Job Title Healey Lane, Batley

Waste Management Strategy

Name	2405-GWP-00-00-D-A-(00)-0007		
Scale	1:500@A3	Revision	C04
Drawn/Checked	MK/DT	First Issue	27.06.25
Drawing Status	Technical Design - A04

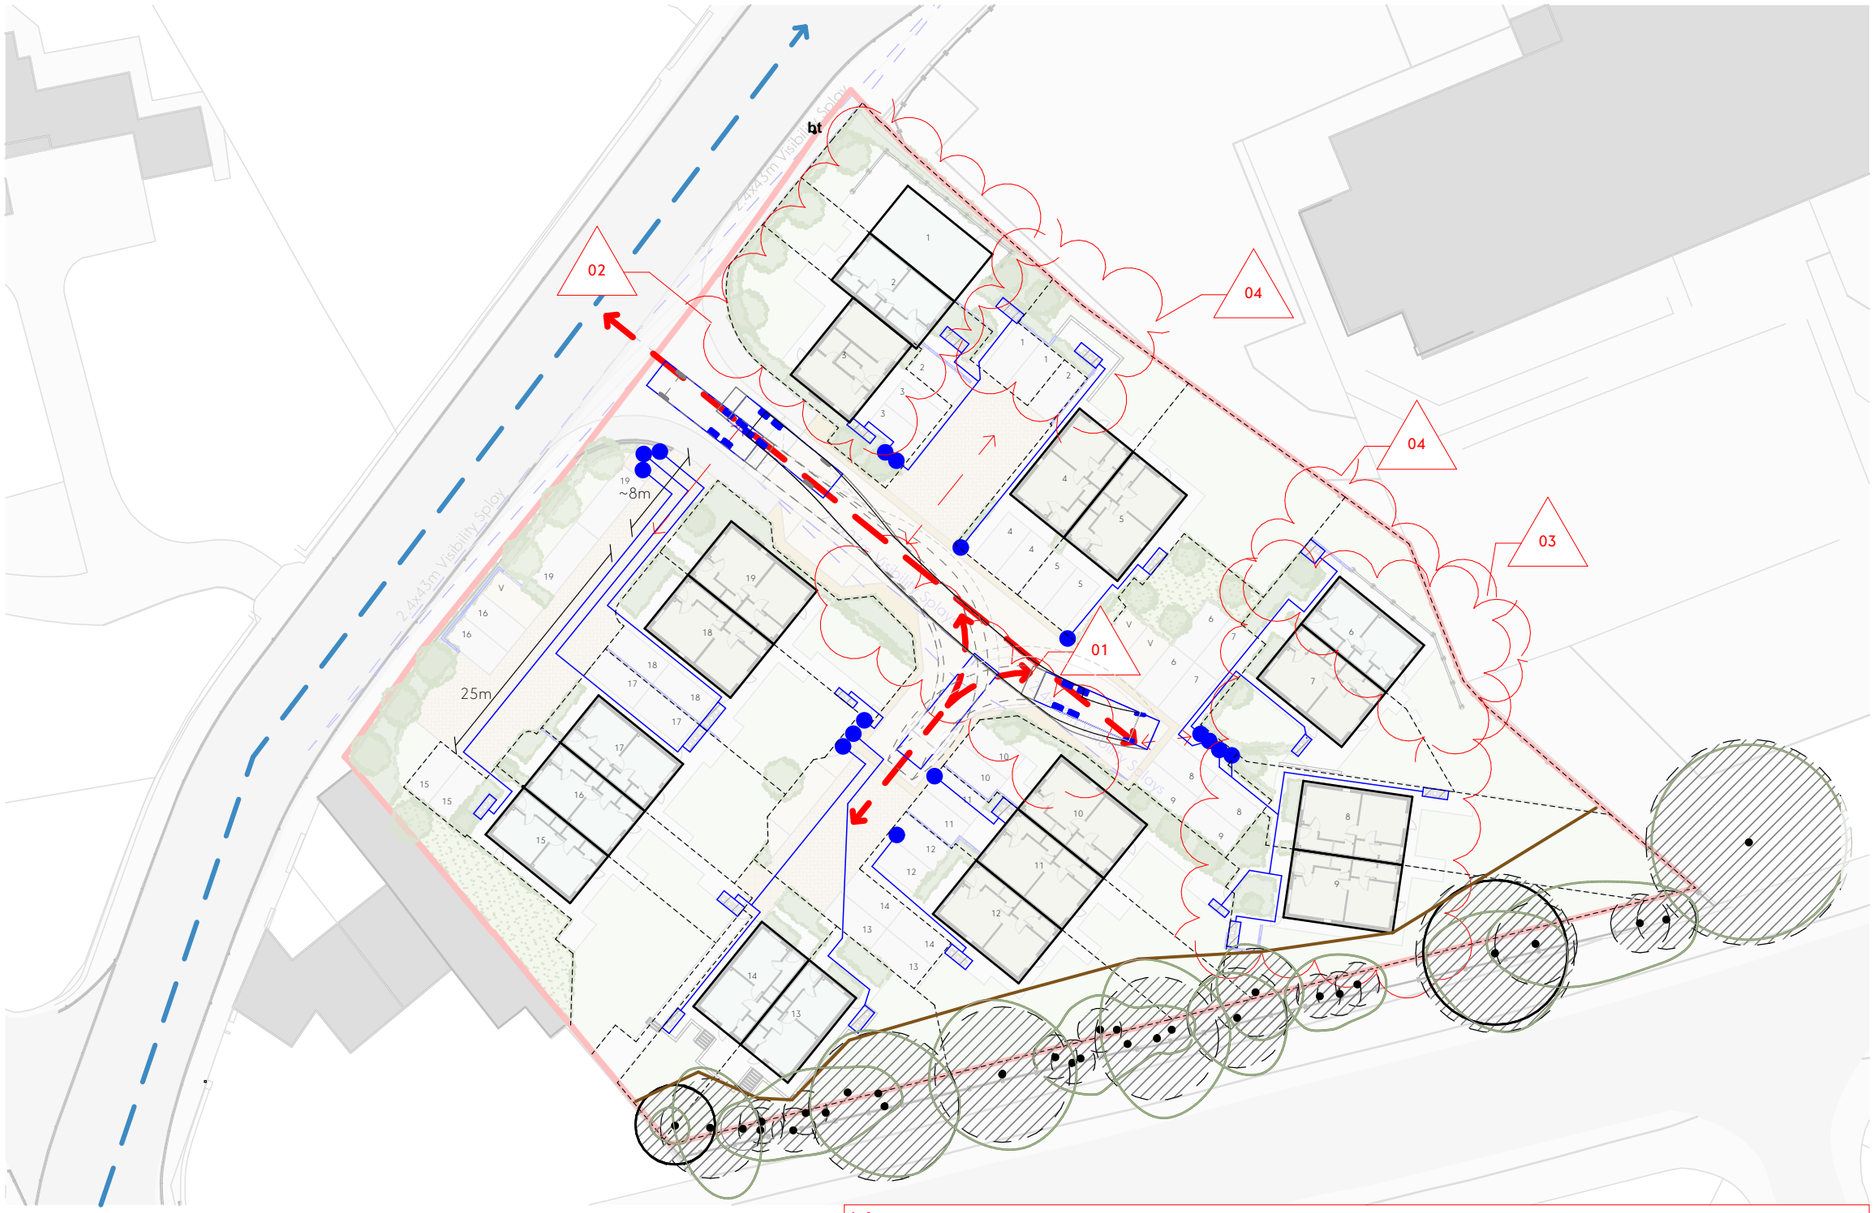
01. Internal road layout revised to suite highway sectional approval (visibility splays to central junction adjusted).
02. Plot A moved by circa 400mm towards N-E and circa 100mm towards S-W to suite retaining wall engineering.
03. Site levels and FFL have been adjusted to reduce landfill/cut, and to suit the as designed adopted highways and site drainage.
04. Changes to boundary treatments to following the revised levels
05. Windows adjusted following building regulations Part O (overheating) assessment. First floor bedroom windows now with double opening sashes (for purge ventilation).
